## **REMARKS**

The present Amendment responds to the Office Action dated December 22, 2006. Concurrently filed is a petition for three-month extension of the period in which to respond to the Office Action.

FIGURE 1

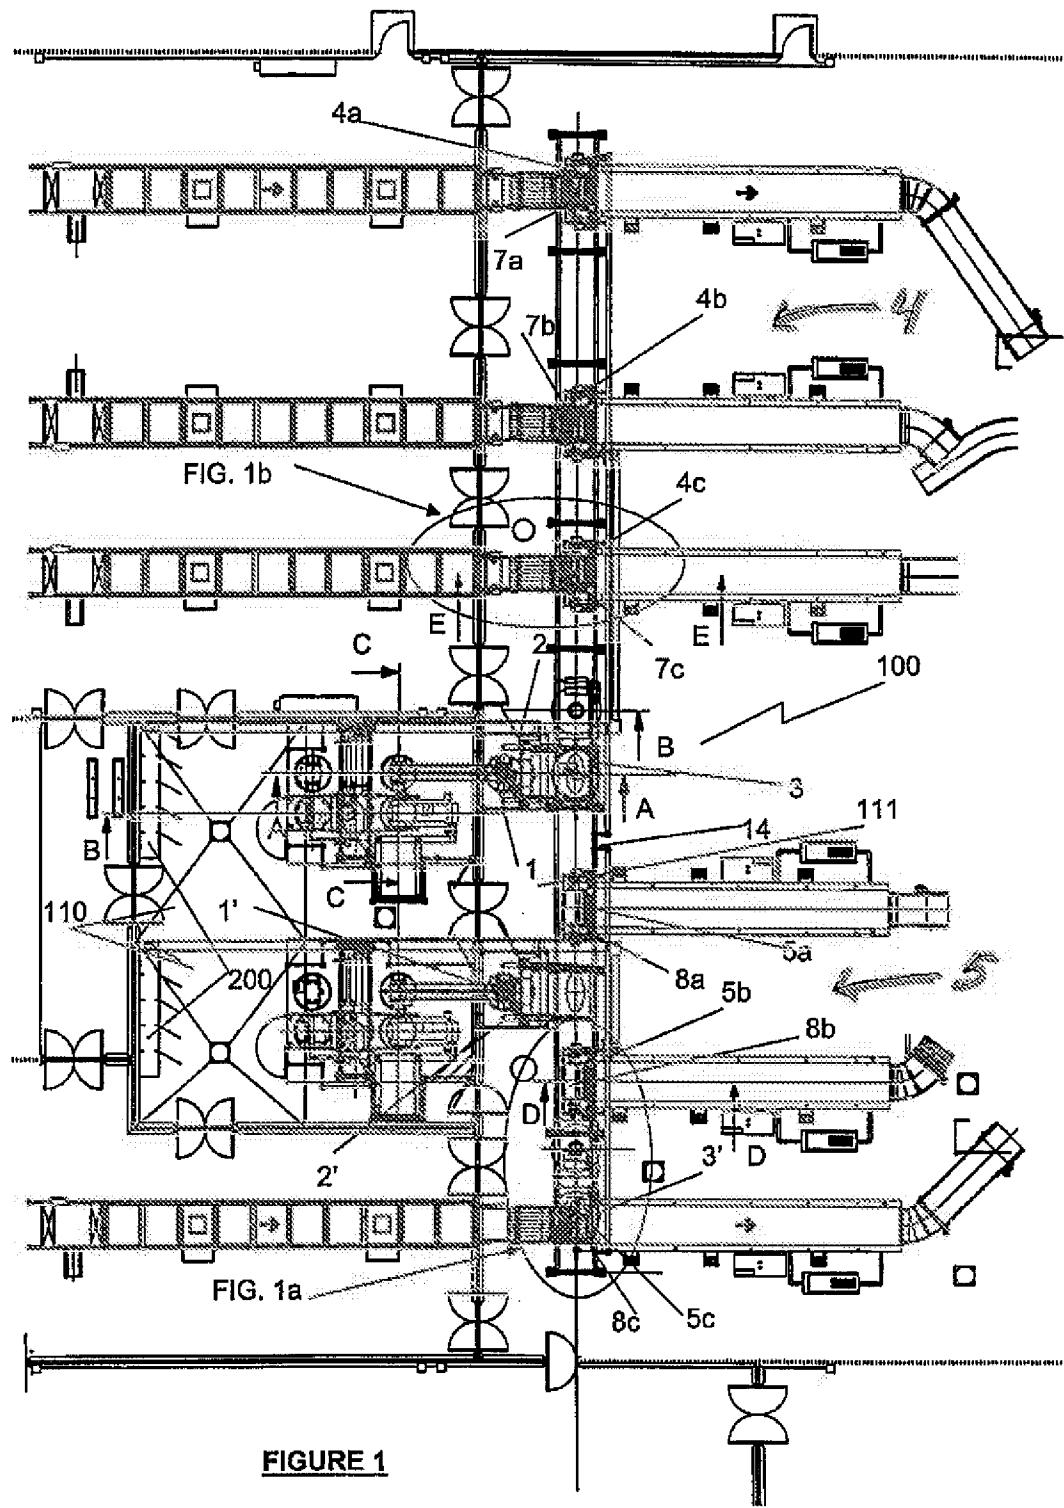
The examiner asked review to ensure all reference characters in the drawings are described in the detailed description and all reference numerals in the specification are included in an appropriate drawing.

Figure 1 is amended to include reference numeral 4 and 5.
